XR100/XR500 Series

Version 211 Software Update

TU-0651 © 2012 Digital Monitoring Products, Inc.

463C CDMA Cellular Communicator

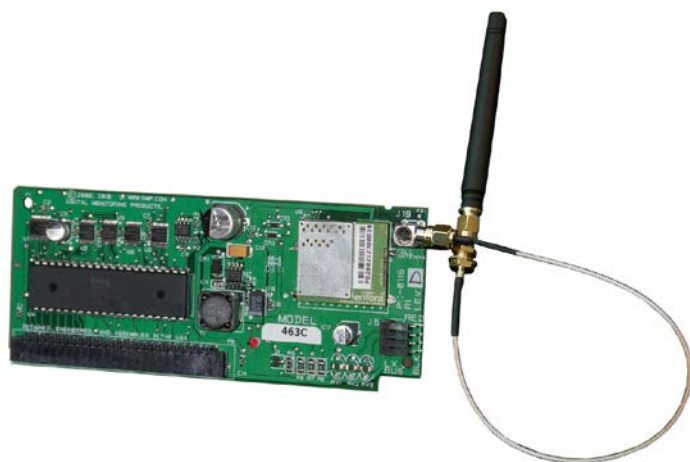
XR100/XR500 Series panels with Version 211 now support CDMA cellular communication when using the new Model 463C CDMA Cellular Communicator.

- Plug-in or external communication module available for XR100/XR500 Series™ panels
- Plug-and-play installation and activation
- Uses digital cellular CDMA data networks in the US
- Cellular data throttling offers overage suppression
- Direct cellular communication enables a direct path for alarm signals from the panel to the monitoring station
- Transmits SMS status messages to multiple recipients
- No additional external support equipment required
- Can be equipped with local or remote antenna, with simple conduit knockout for in-panel installations
- Check signal strength indication at the keypad
